WATER PERMIT NO. 2690-2

Application For Permit To Appropriate Water Within The State Of South Dakota

**RECOMMENDATION OF CHIEF ENGINEER FOR WATER PERMIT
APPLICATION NO. 2690-2, Chris B Snavely**

REPORT ON
WATER PERMIT APPLICATION No. 2690-2
Chris B. Snively
August 29, 2012

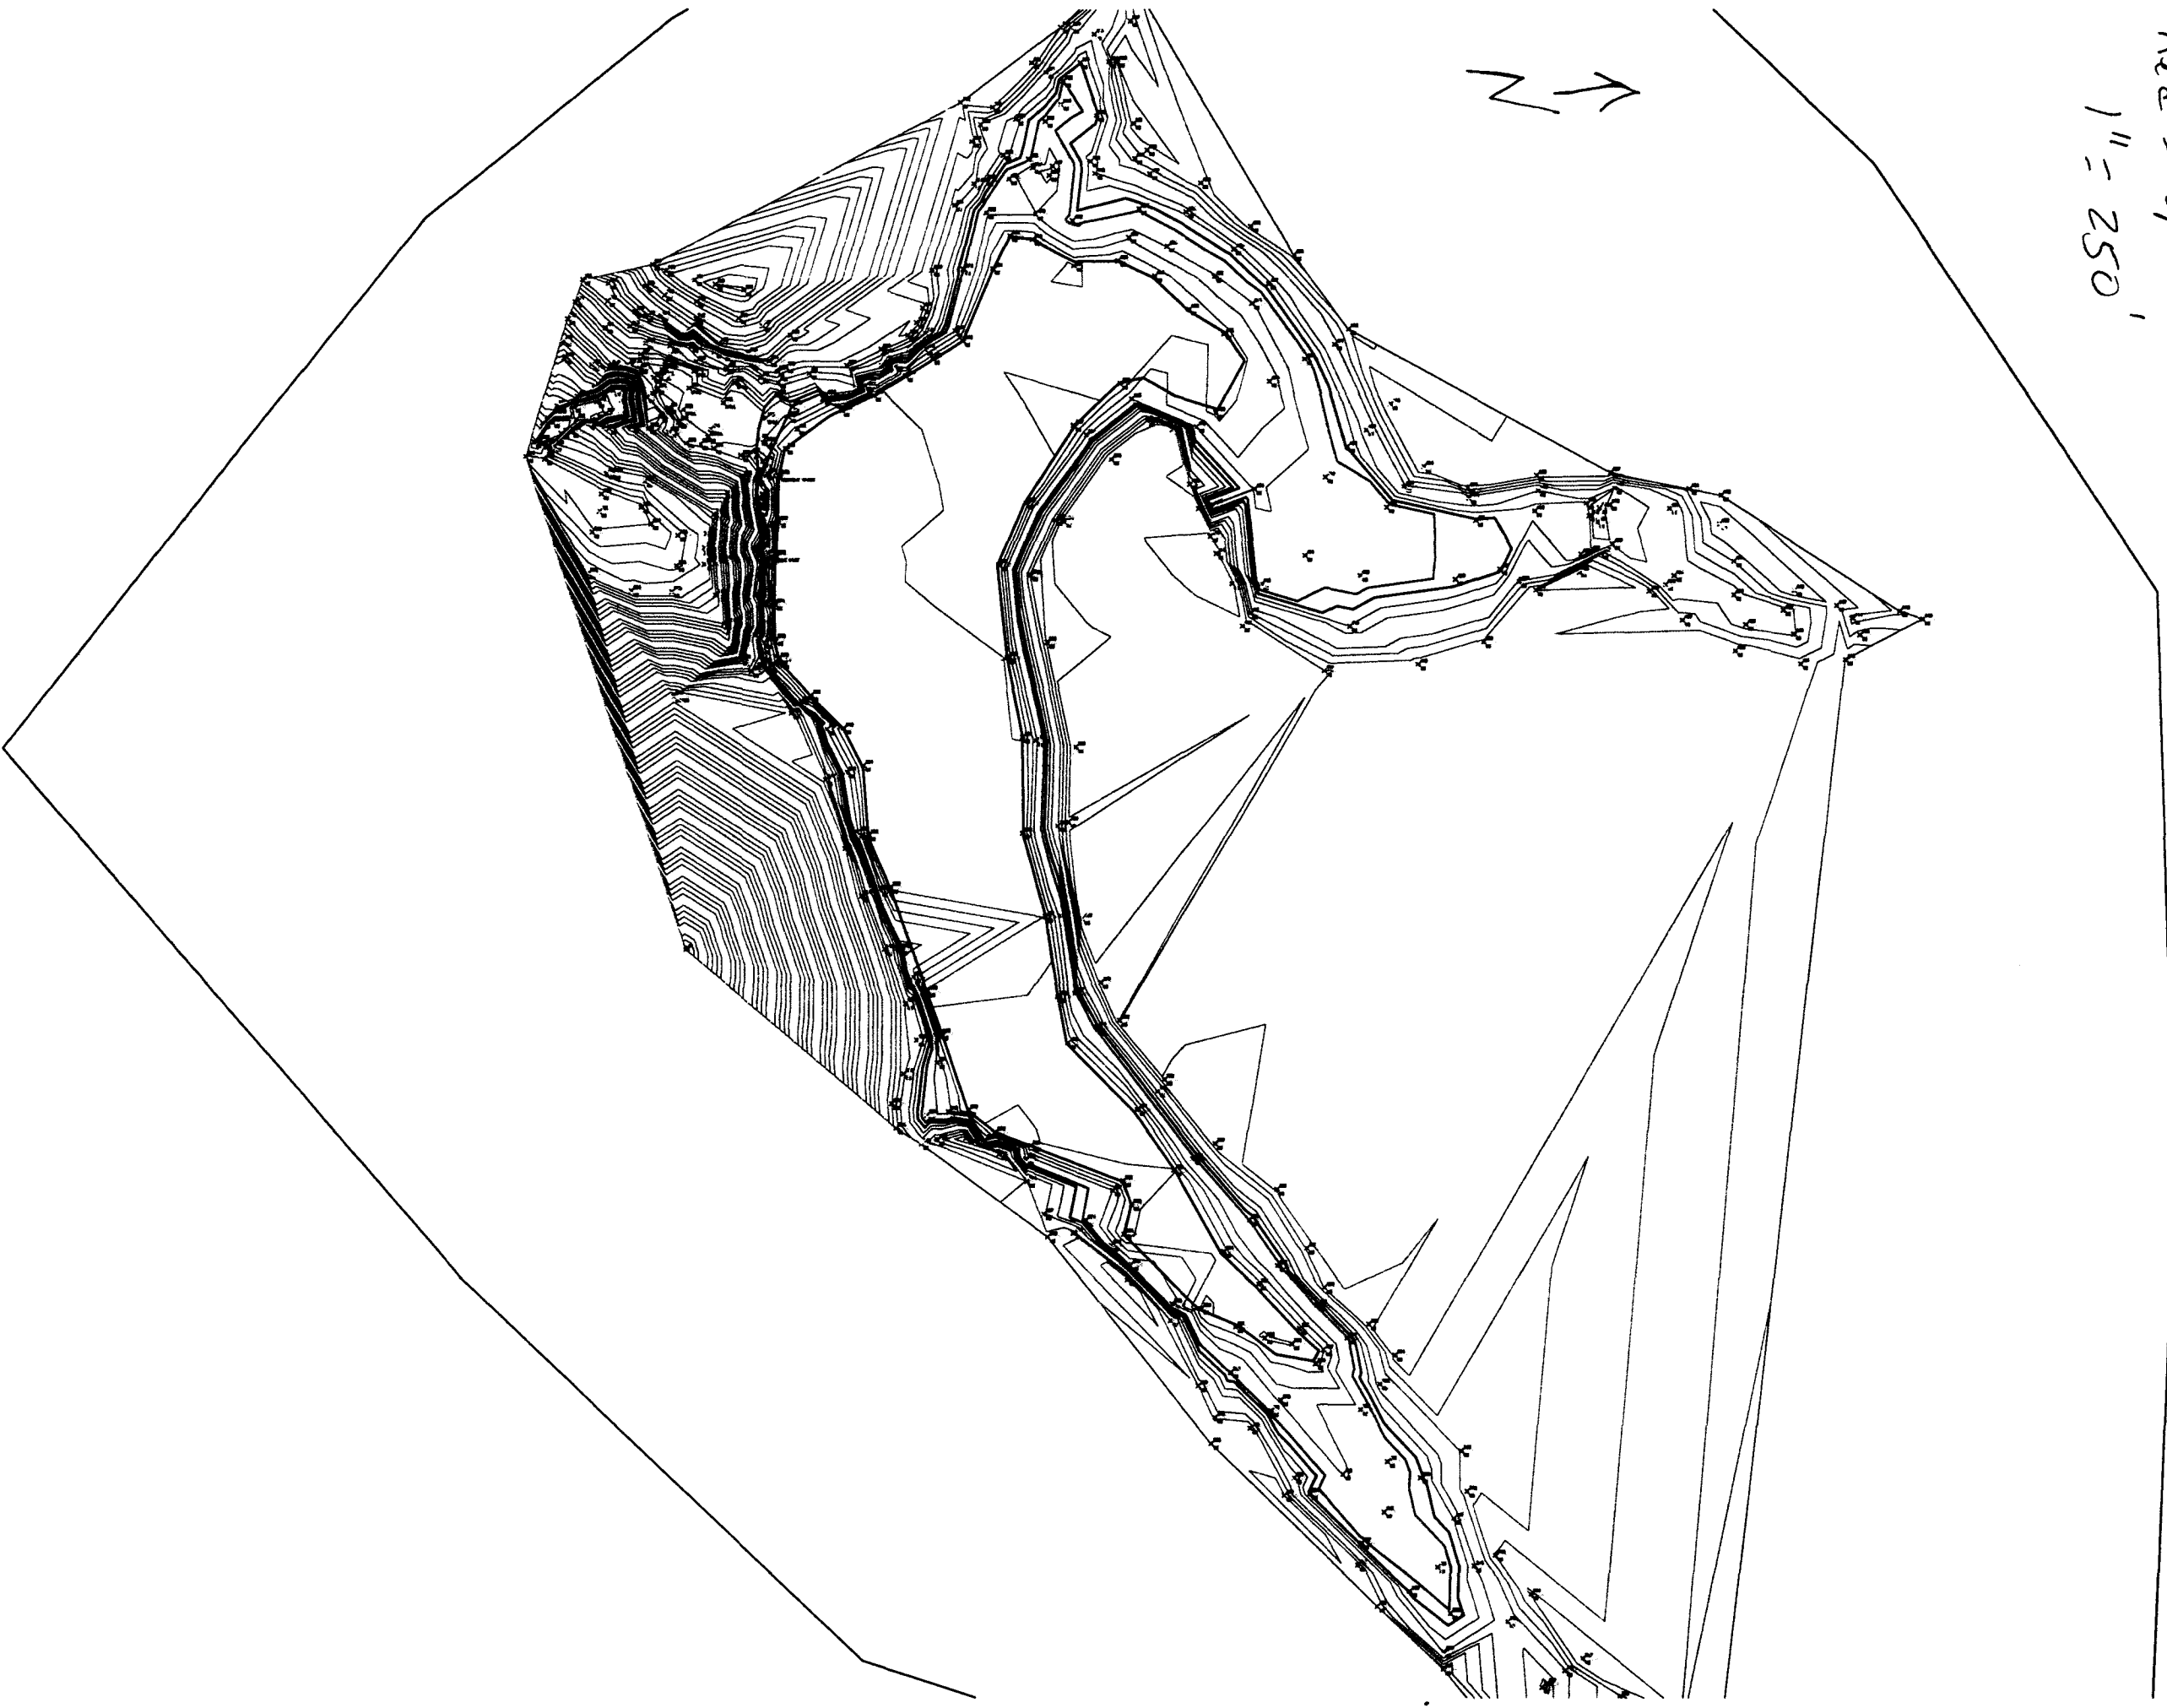
1. Topo Map - OK
2. Dam Axis Profile - OK
3. Dam Max X-Sec - OK
4. Area - Capacity - OK
5. Outlet Details - OK
6. Spillway Rating - OK
7. Spillway Details - OK
8. Specs - std. NRCS - OK
9. EPP - N/A Cat. 3 - OK
